Addendum / Addenda

No./N^o
2

Project Description / Description de projet M10-Electrical Vault Ventilation		
Solicitation No./ No de sollicitation 14-22068	Project No./N ^o de projet 4021	W.O. No./N ^o d'ordre de travail A1-004018-02
Project Engineer / Ingénieur de projet Josh Hale (Stantec)		Date November 12,2014
<p>Notice: This addendum shall form part of the tender documents and all conditions shall apply and be read in conjunction with the original plans and specifications.</p>		<p>Nota: Cet addenda fait partie intégrale des dossiers d'appel d'offres; toutes les conditions énoncées doivent être lues et appliquées en conjonction avec les plans et les devis originaux.</p>

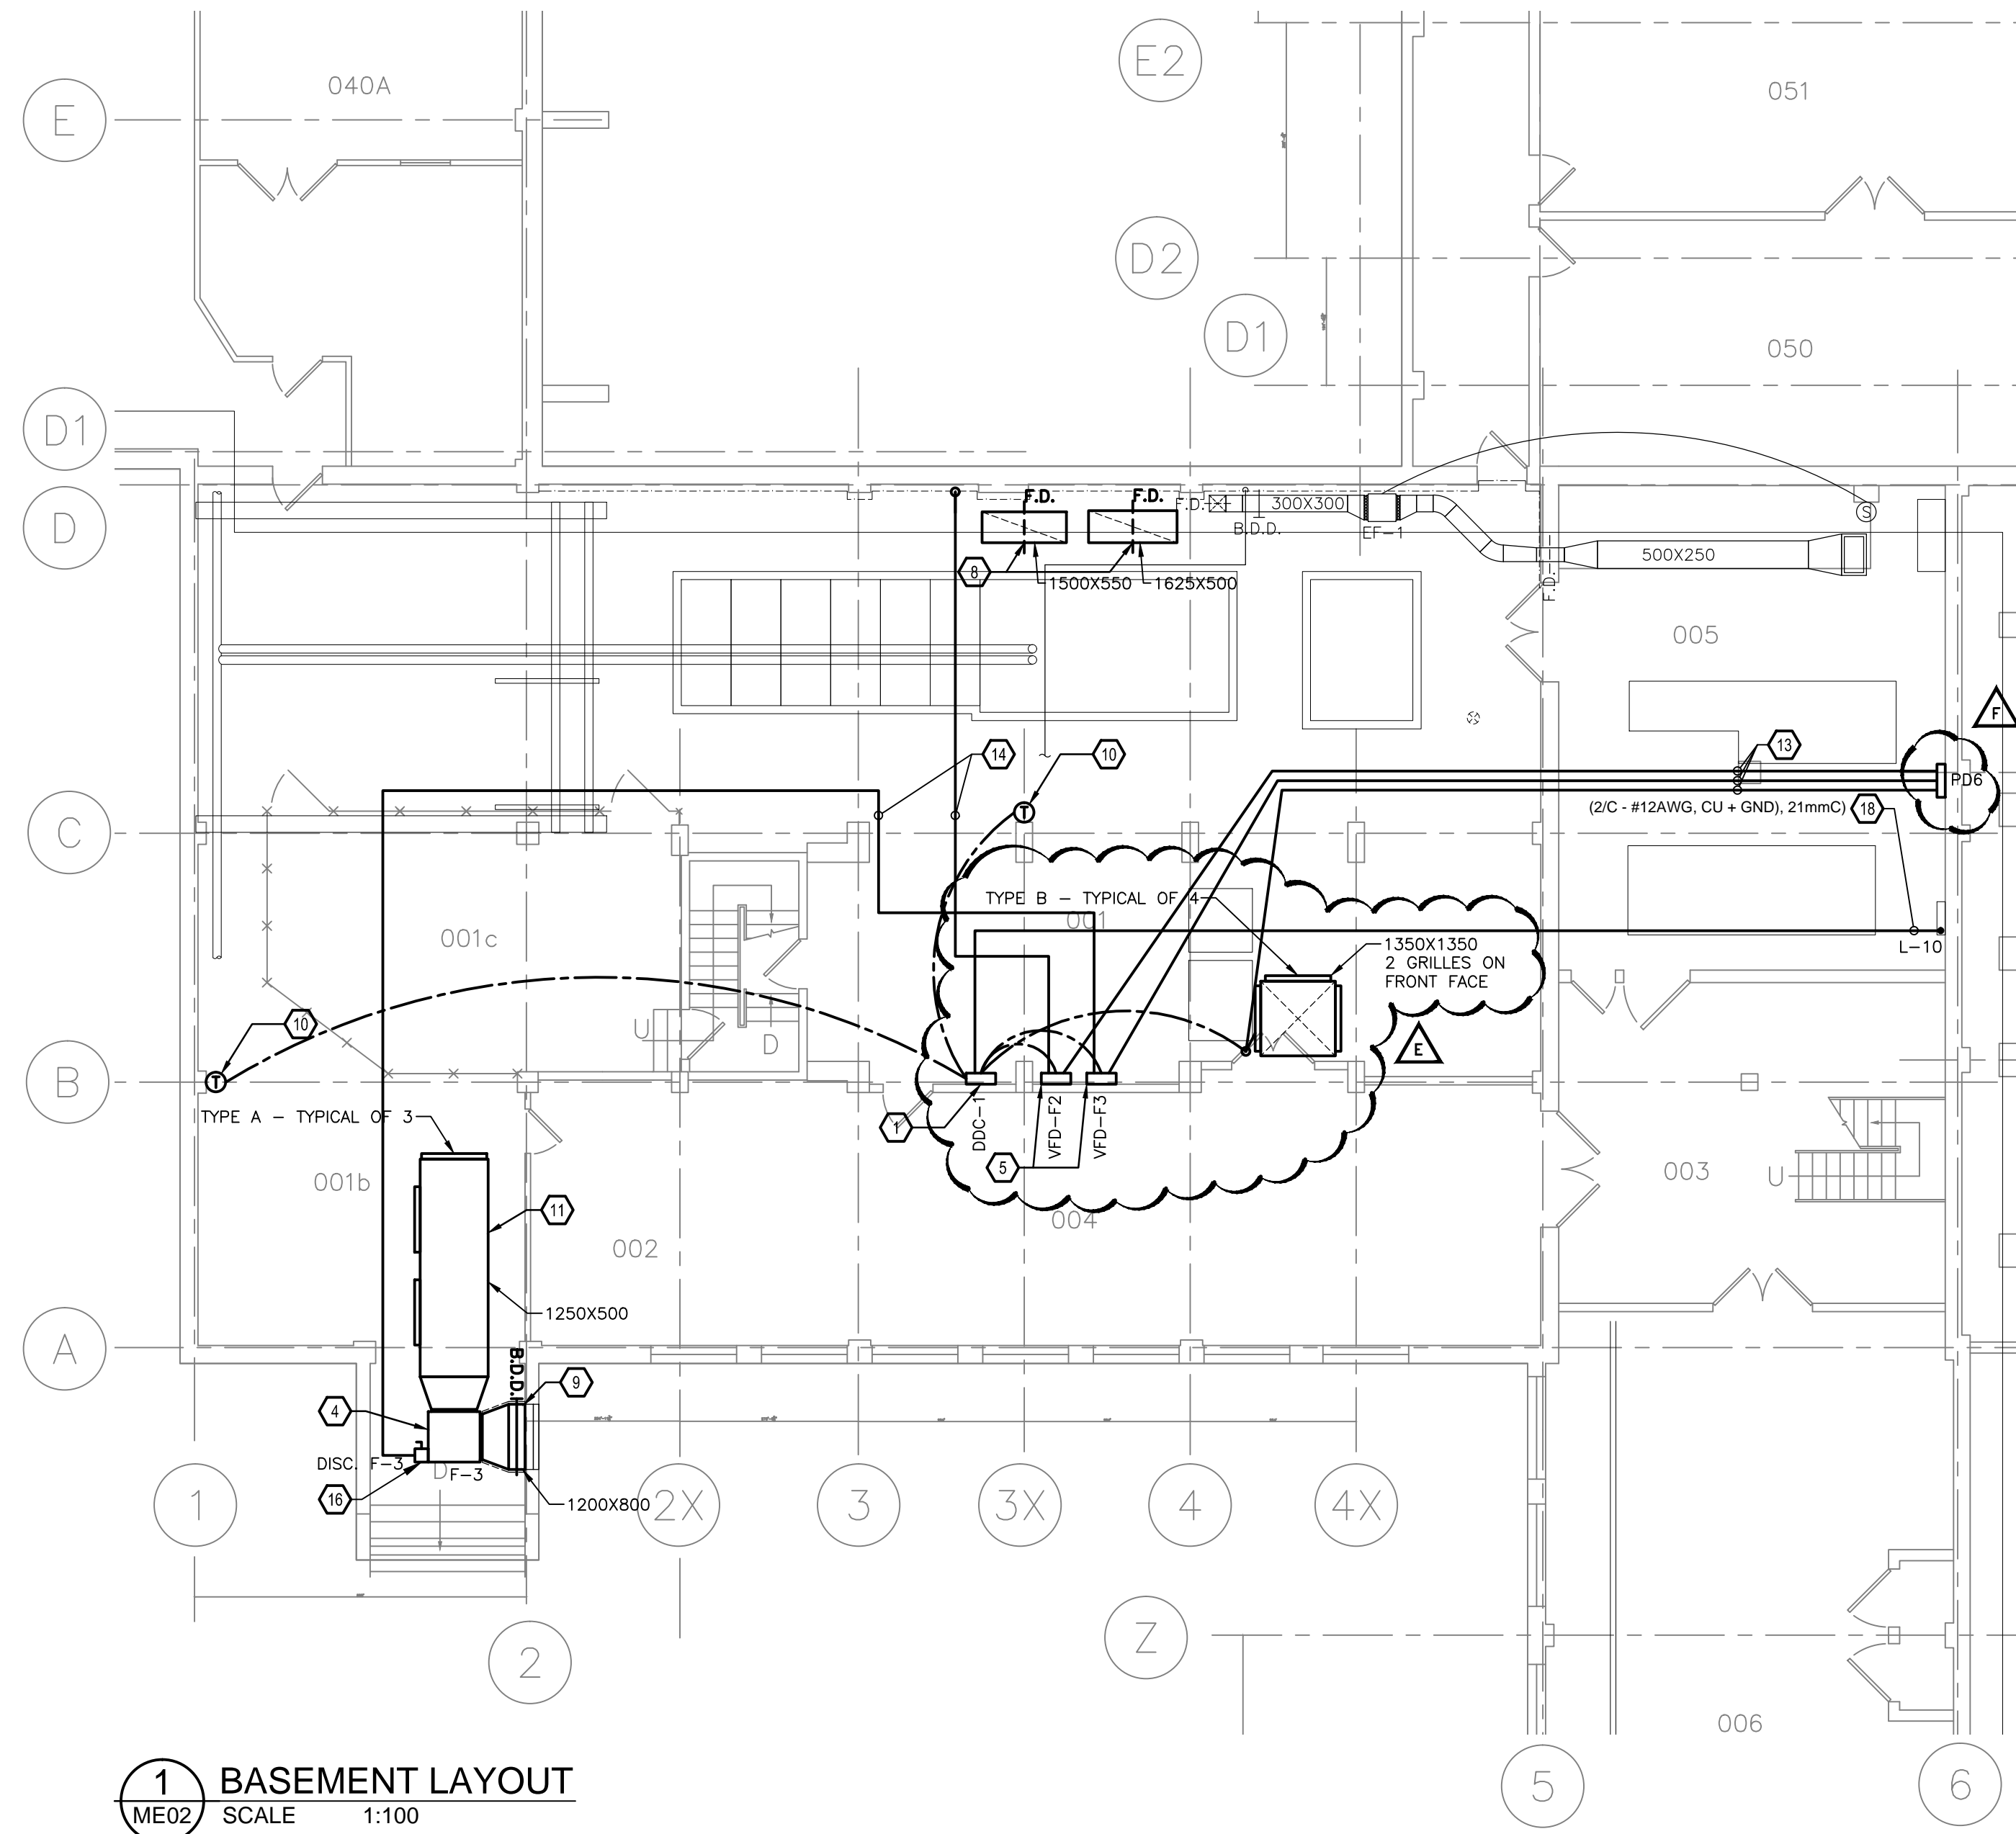
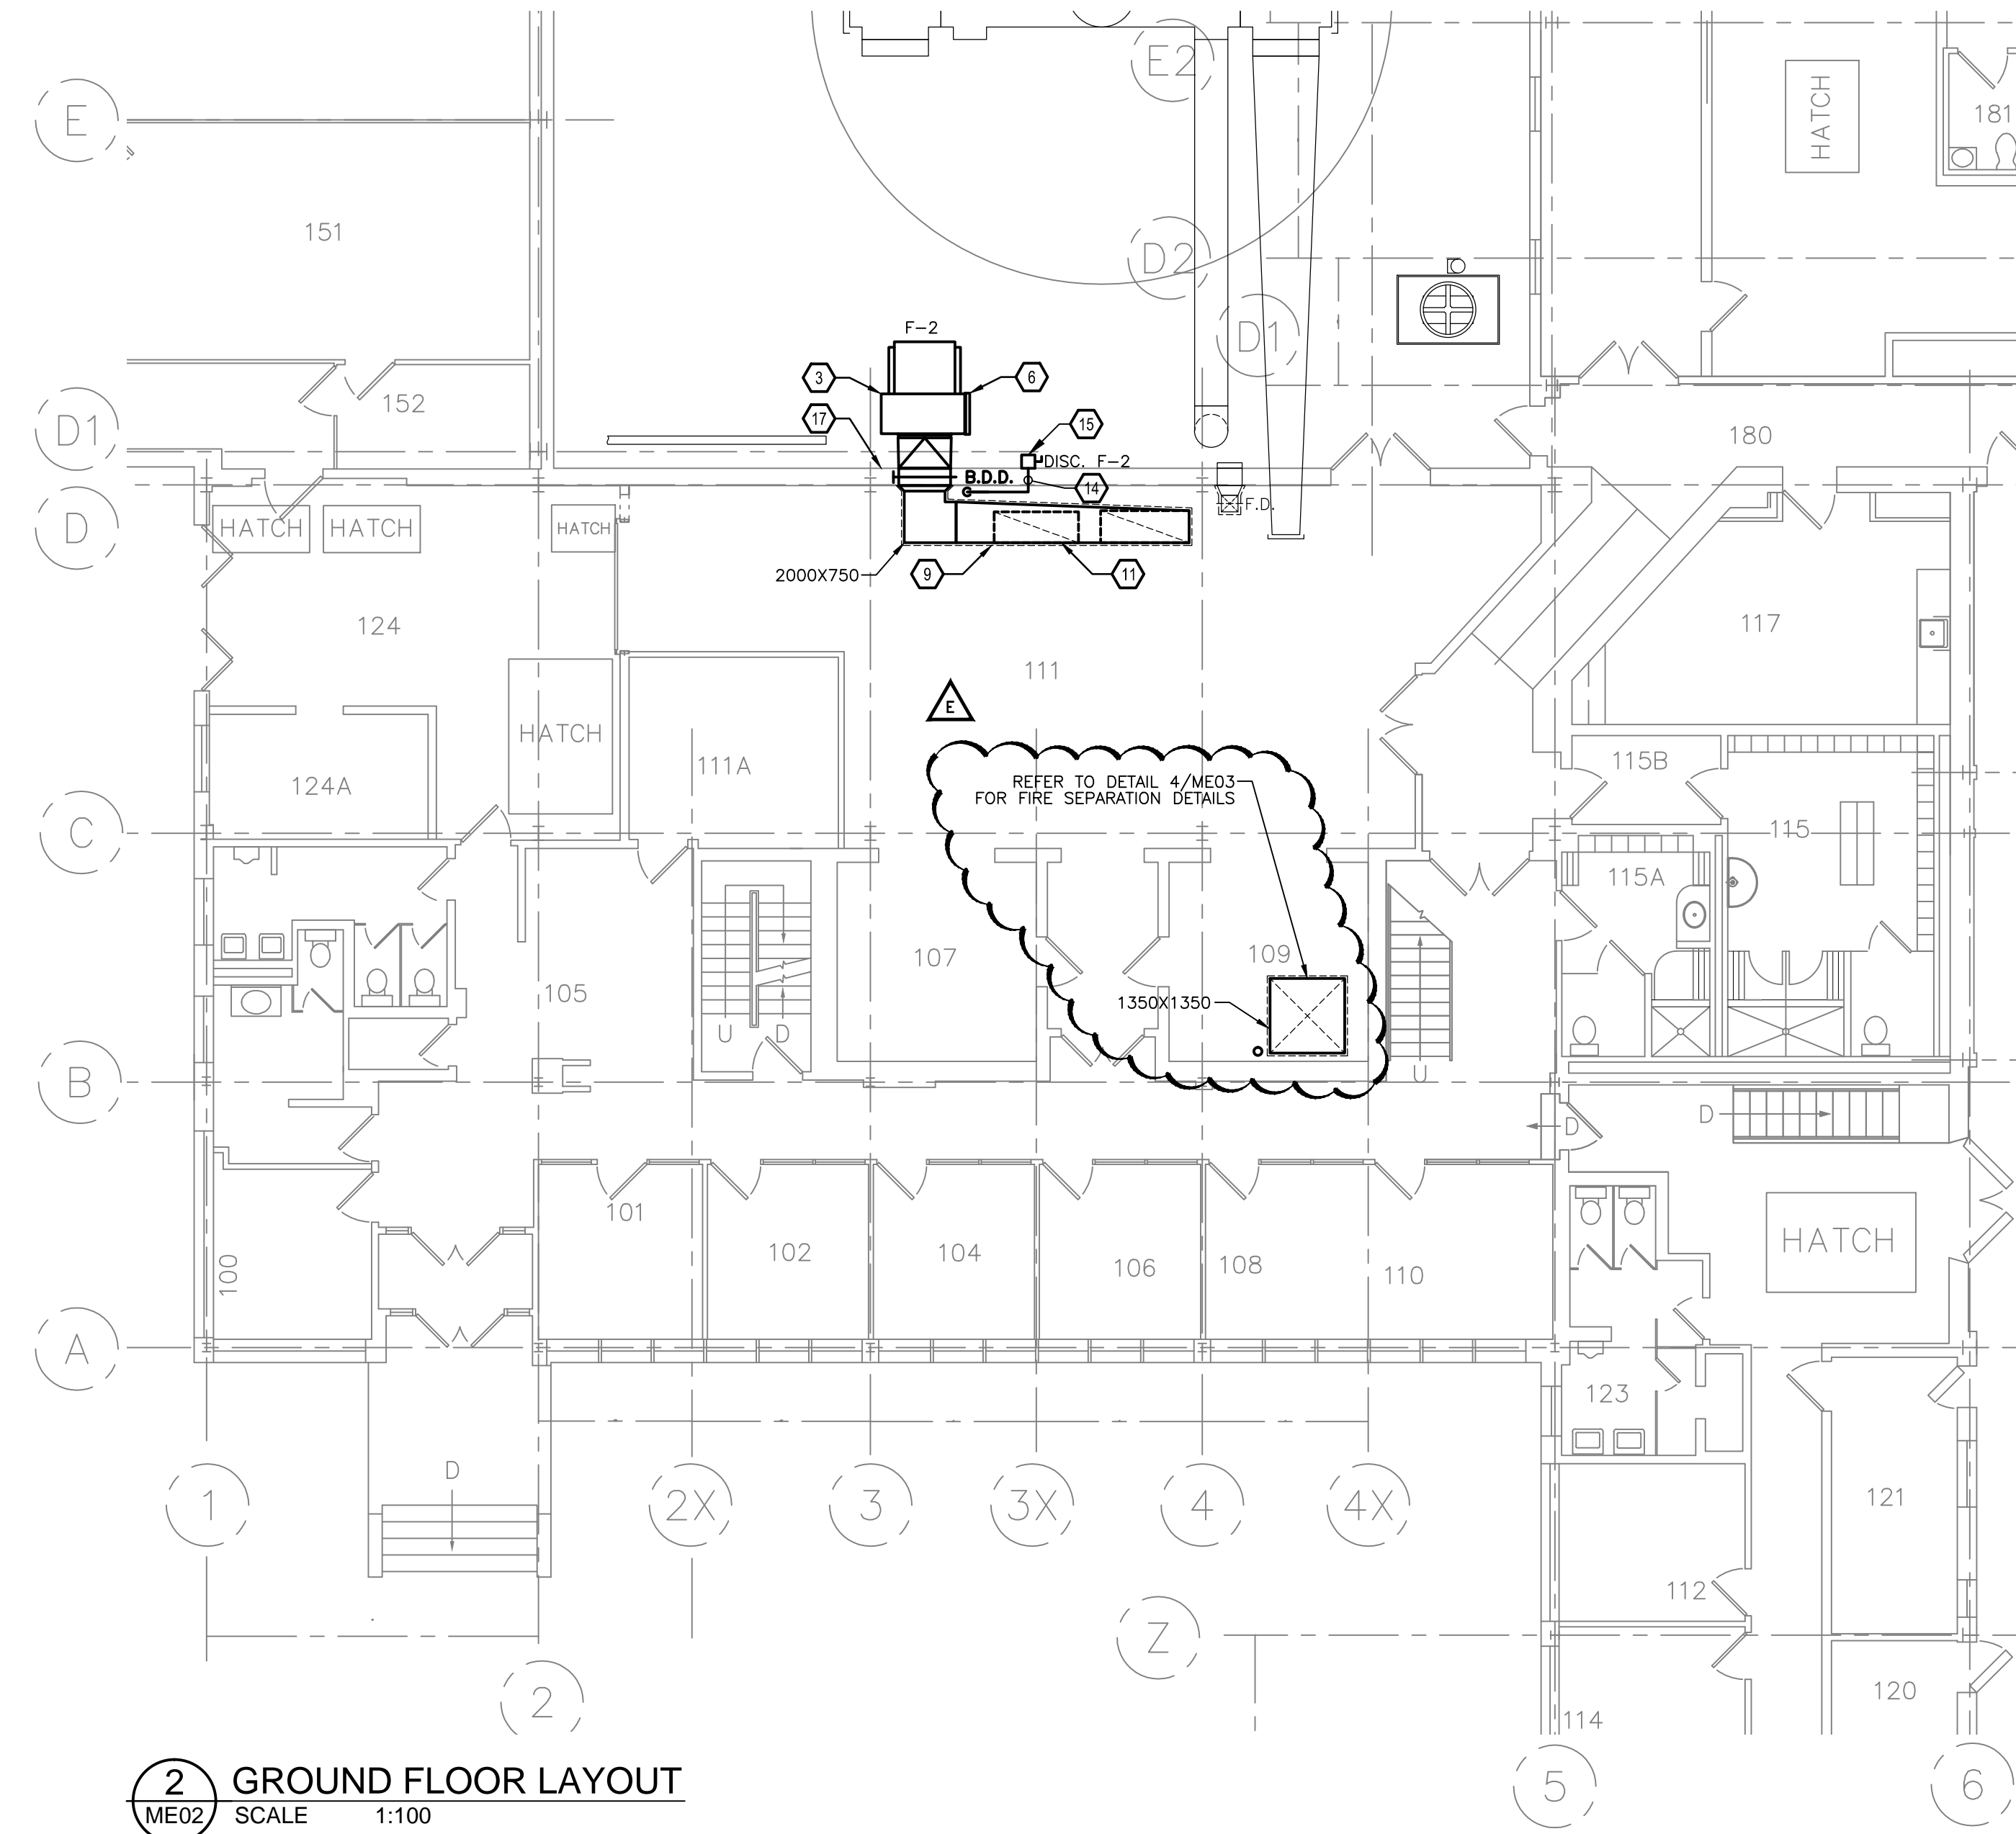
2. Drawings ME02 have been updated to show correct location of PD6
3. Drawings ME03 have been updated to show correct location of VFD, (Fan F-1) VSD to be installed inside room 200 below mezzanine.
4. Drawings ME01 have been updated to show location of piping under new backfill .
